AER Information Request – PIAC RIT-T Dispute

North West Slopes NWSA and BOP.

16 September 2022

Figure 1 – Comparison of no anticipated demand and BOP PACR low scenario unserved energy forecast (MWh)

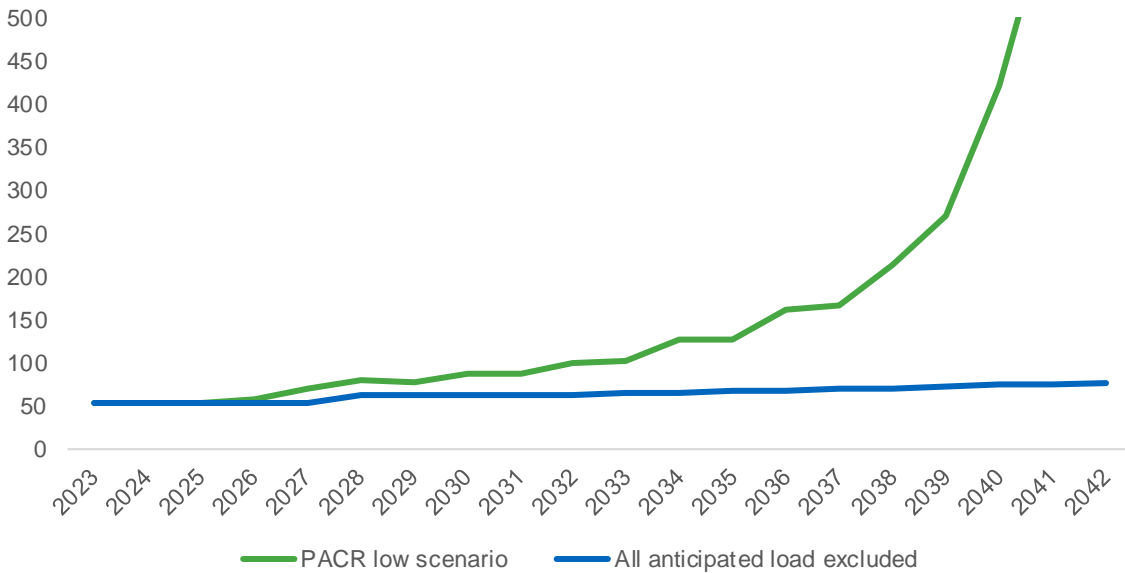
The low demand scenario for BOP does include some anticipated spot load development. Figure 1 presents the difference between the BOP low demand scenario unserved energy forecast and a demand forecast that includes no anticipated load.

Figure 2 – BOP weighted NPV results all anticipated demand excluded with and without 25 per cent increase in network costs, sensitivity 2(v)

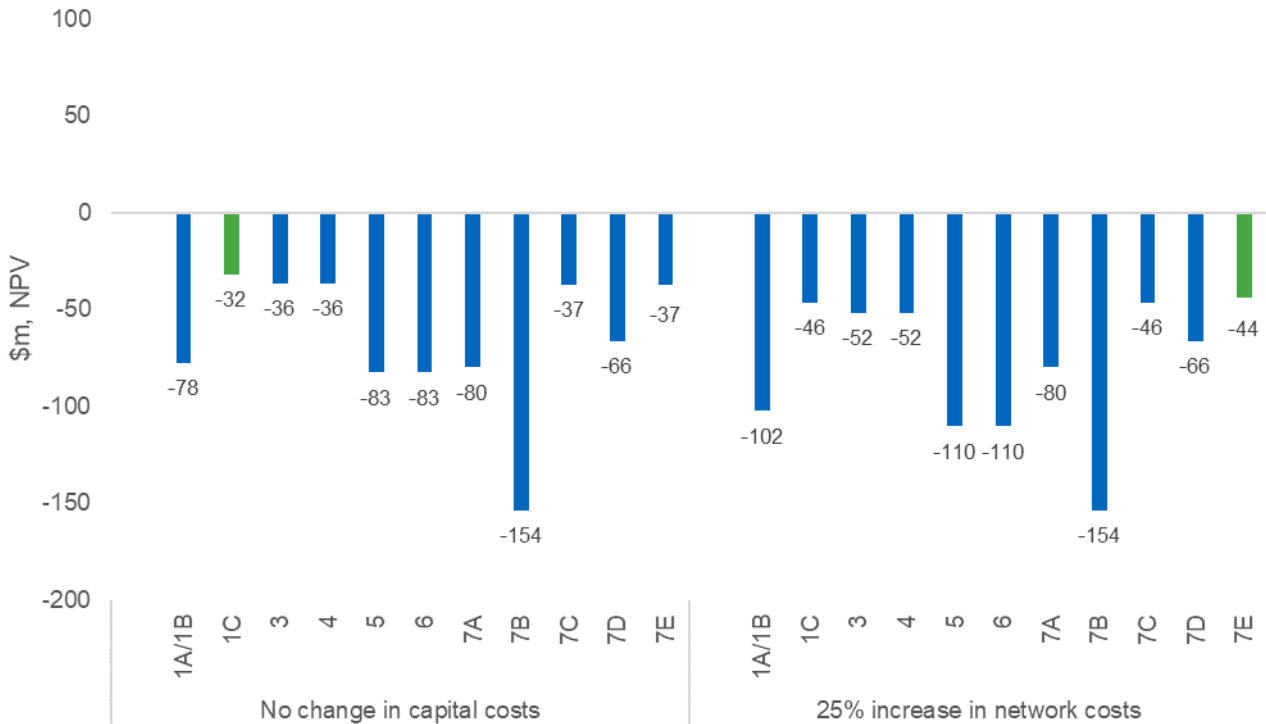
Figure 2 compares the weighted NPV results for this sensitivity with and without a 25 per cent increase in the estimated network costs of the credible options.

The LHS of Figure 1 shows that the removal of all anticipated spot loads has a significant effect on the results relative to the results presented in the core model for the PACR. The weighted NPV of all options falls substantially, and all options are expected to deliver net costs.

The 25% increase in network capital costs has a much smaller effect compared to the effect of removing the anticipated spot loads included.

Without the 25 per cent increase in capital costs, Option 1C becomes the preferred option as a result of removing anticipated spot loads, delivering a weighted NPV of -\$31.8 million. Option 3, Option 4, Option 7C and Option 7E are all projected to deliver \$36 million to \$37 million in net costs.

The 25 per cent increase in network costs has a greater effect on the network options (including Option 1C, Option 3 and Option 4) compared to the options involving NNO (ie, 7A-7E) because the former are comprised exclusively of network components. In this case, Option 7E becomes the preferred option with an expected net cost of \$44 million.

With and without the 25 per cent increase in capital costs, Option 7E, Option 7C and Option 1C are ranked within \$6 million of each other.

Figure 3 – BOP weighted NPV results all anticipated demand excluded with and without 25 per cent increase in network costs, sensitivity 2(v), avoided unserved energy zeroed out after 2027/28

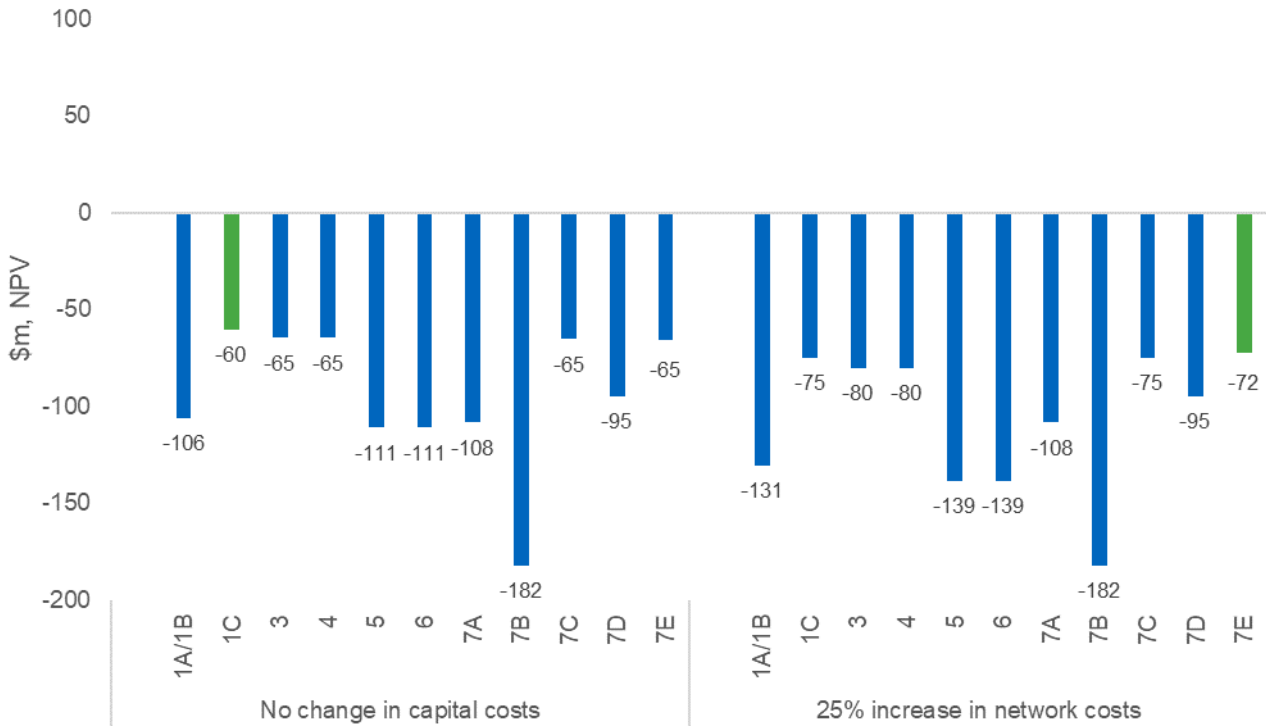
Figure 3 shows the weighted NPV results for this sensitivity where avoided unserved energy remains zeroed out after 2027/28. As noted above, this was done in the PACR to make the results of the central and high scenarios readable. Transgrid considers this approach to be less relevant for this sensitivity, but has provided this information for completeness.

Figure 4 – BOP weighted NPV results based on low demand scenario and with and without 25 per cent increase in network costs, sensitivity 2(v)

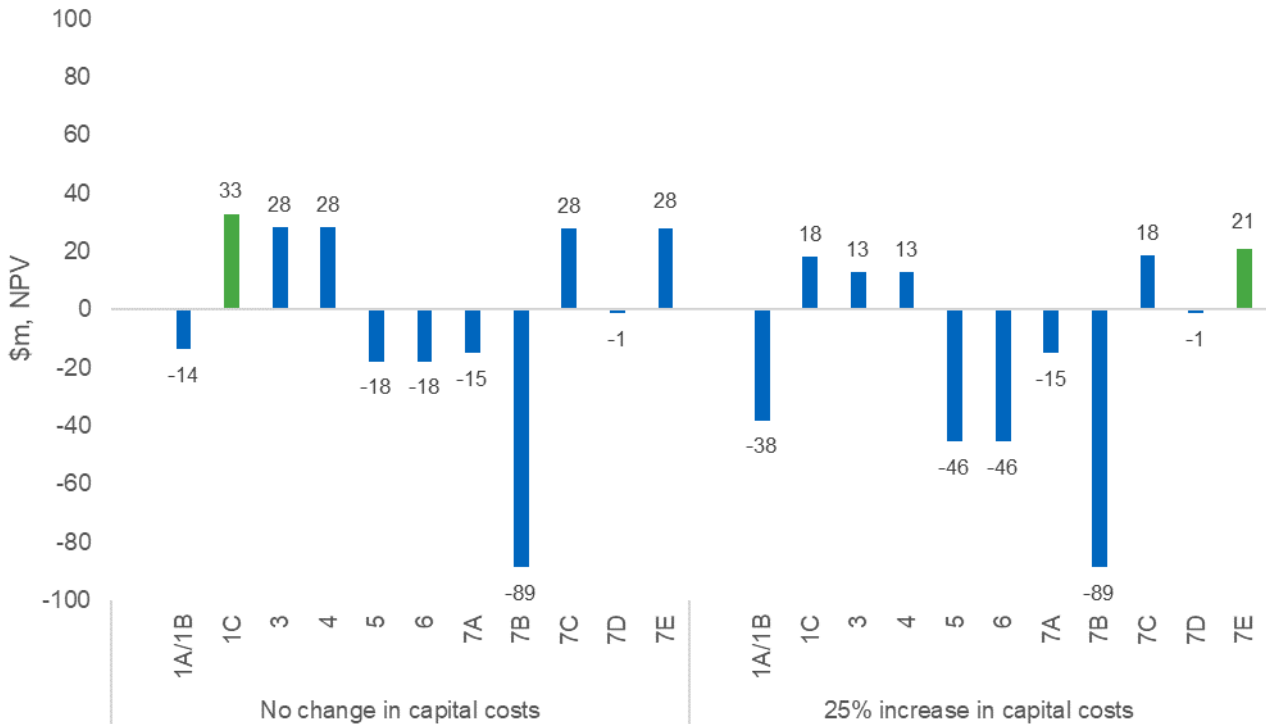
Figure 4 compares the weighted NPV results for this sensitivity with and without a 25 per cent increase in the estimated network costs of the credible options.

The LHS of Figure 1 shows that the focus on the low demand scenario in the PACR has a significant effect on the results relative to the results presented in the core model for the PACR. The weighted NPV of all options falls substantially.

The 25% increase in network capital costs has a much smaller effect compared to the effect of reducing the amount of anticipated spot loads included.

Without the 25 per cent increase in capital costs, Option 1C becomes the preferred option as a result of assuming the low demand scenario, delivering a weighted NPV of \$32.8 million. Option 3, Option 4, Option 7C and Option 7E are all projected to deliver approximately \$28 million in net benefits.

The 25 per cent increase in network costs has a greater effect on the network options (including Option 1C, Option 3 and Option 4) compared to the options involving NNO (ie, 7A-7E) because the former are comprised exclusively of network components. In this case, Option 7E becomes the preferred option with a weighted NPV of \$20.9 million.

With and without the 25 per cent increase in capital costs, Option 7E, Option 7C and Option 1C are ranked within \$5 million of each other.

Regardless of whether the network capital costs are 25 per cent higher or in line with core estimates, Option 7E has a positive NPV in the central and high scenarios and a negative NPV in the low scenario.

Figure 5 - BOP weighted NPV results based on low demand scenario and with and without 25 per cent increase in network costs, sensitivity 2(v), no avoided unserved energy after 2027/28

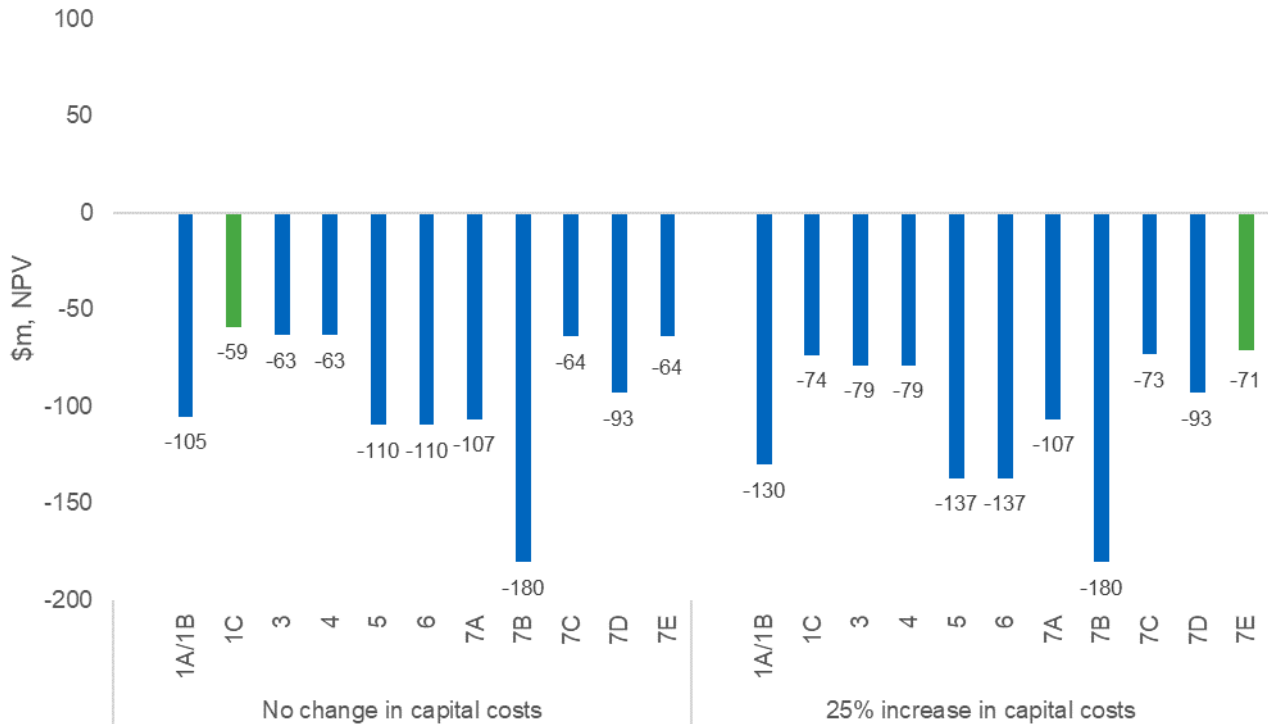
Figure 5 shows the weighted NPV results for this sensitivity where avoided unserved energy remains zeroed out after 2027/28. As noted above, this was done in the PACR to make the results of the central and high scenarios readable. Transgrid considers this approach to be less relevant for this sensitivity, but has provided this information for completeness.

Figure 6 – North West Slopescentral scenario NPV results without Narrabri gas, sensitivity 3 (viii), post 2028/29 avoided USE excluded

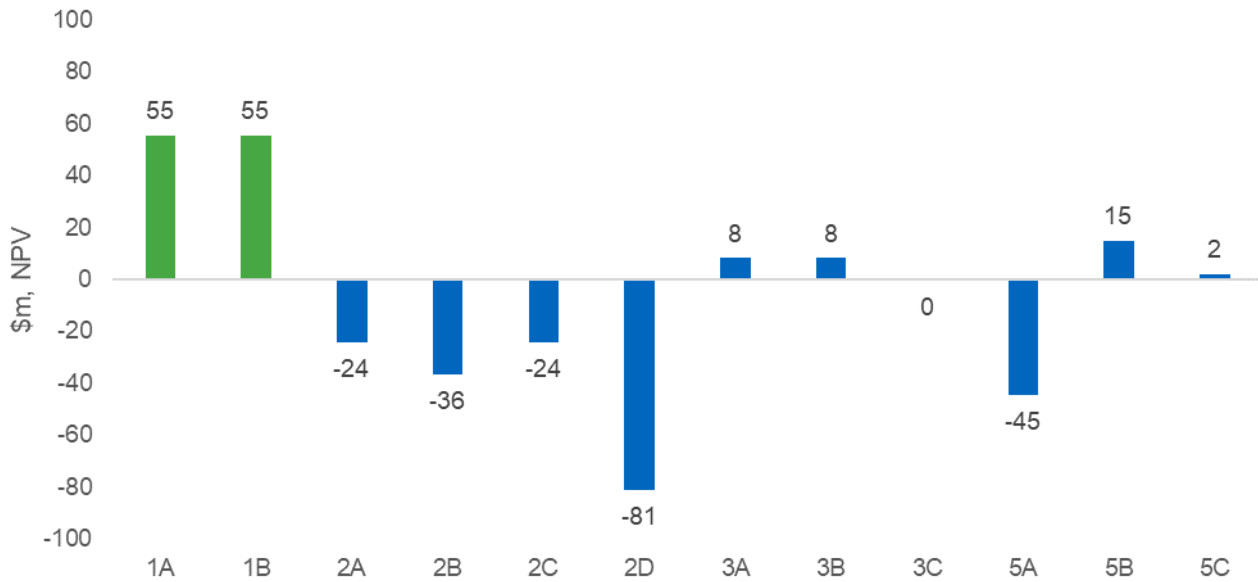
- (viii) Please provide an NPV sensitivity analysis (updated NPV cash flow model) where the Narrabri Gas Project is excluded from the low and central scenarios.

Figure 6 and the attached “NWS model question 3 viii post 2029 avoided USE excluded” set out the results of this sensitivity analysis with avoided unserved energy zeroed out after 2028/29. Avoided unserved energy was zeroed out after 2028/29 in the PACR to improve the readability of results.

The results show that Option 1 (ie, Option 1A or Option 1B) is the preferred option under this sensitivity. Option 1 involves building a 50 MVAR SVC at Gunnedah substation in 2025/26. This is the lowest cost option under this sensitivity.

Figure 8 – BOP weighted NPV results with Parkes SAP excluded, sensitivity 3(xii), no avoided unserved energy after 2027/28

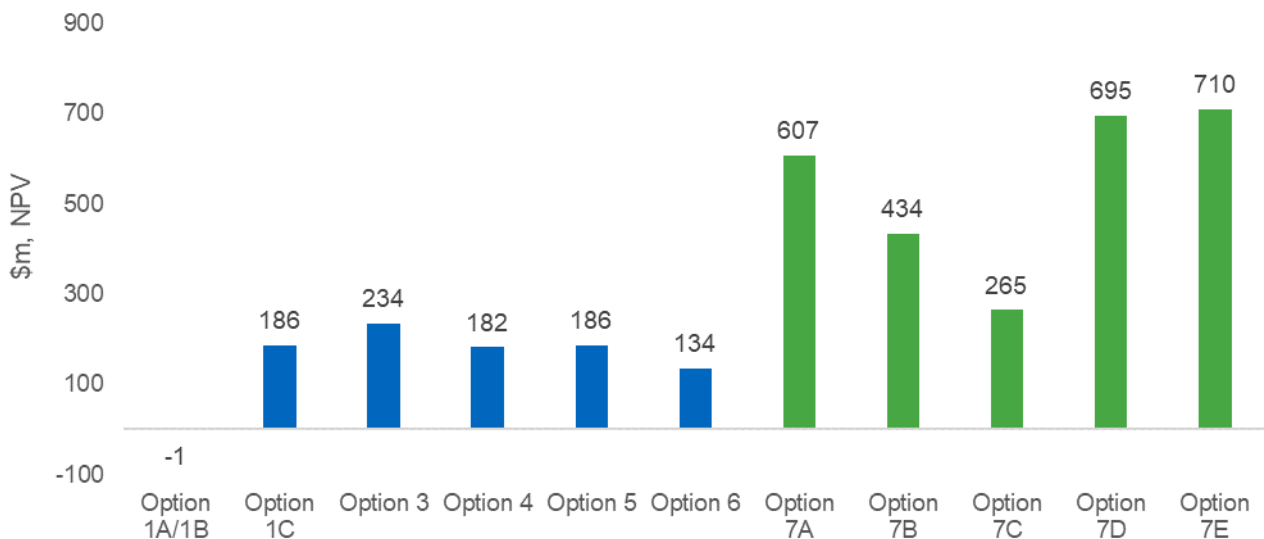
- (xii) Please provide an NPV sensitivity analysis (updated NPV cash flow model) where the Parkes Special Activation Project is excluded from all scenarios in the BOP PACR.

We have updated the unserved energy inputs and the series of investments under each option in each scenario to reflect the exclusion of Parkes SAP from the analysis.

Figure 8 presents the weighted NPV results of this sensitivity with avoided unserved energy after 2027/28 excluded from the analysis.

Figure 10 – BOP weighted NPV results, 5.5 per cent discount rate in all scenarios

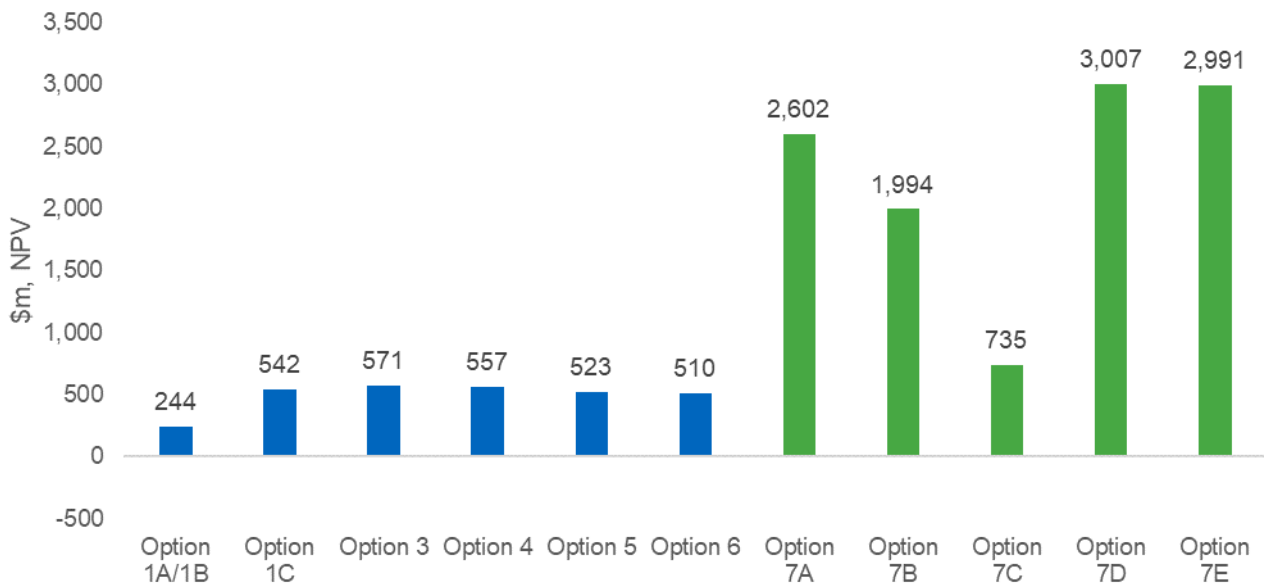
- (i) Please provide an NPV sensitivity analysis (updated NPV cash flow models) for each scenario using the central discount rate, the upper bound discount rate and the lower discount rate and advise if the adoption of a common discount rate between scenarios changes the rankings of the options.

The adoption of a common discount rate between scenarios does not change the rankings of the options for any of the central, upper bound, lower bound or 'updated regulated' discount rates.

Figure 10 shows the weighted NPV results using a discount rate of 5.5 per cent across all scenarios.
